## Technical Service Bulletin

<b>Topic</b>	93 e-tron GT: converting high-voltage battery charger from 22kW to 11 kW
<b>Market area</b>	United States 444 Volkswagen of America, Inc. (6444)
<b>Brand</b>	Audi
<b>Transaction No.</b>	2078782/2
<b>Level</b>	EH
<b>Status</b>	Released for publishing
<b>Release date</b>	Sep 23, 2025

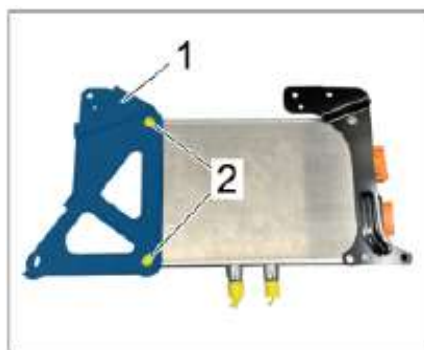
The brackets must be modified to install the 11 kW high-voltage battery charger:

a) Modify the bracket of the 22 kW high-voltage battery charger to fit the 11 kW high-voltage battery charger

Both brackets of the 22 kW high-voltage battery charger (position 1) are removed (see following image).

Fit one of the two previously removed brackets at position 1 (see following image) on the new 11 kW high-voltage battery charger using the new shorter (M6x18) bolts (see position 2). The tightening torque is 8 Nm.

b) Secure new bracket

The new bracket is fitted to the side facing away from the connector using the **new, shorter (M6x18)** bolts (see following image). The tightening torque is 8 Nm.
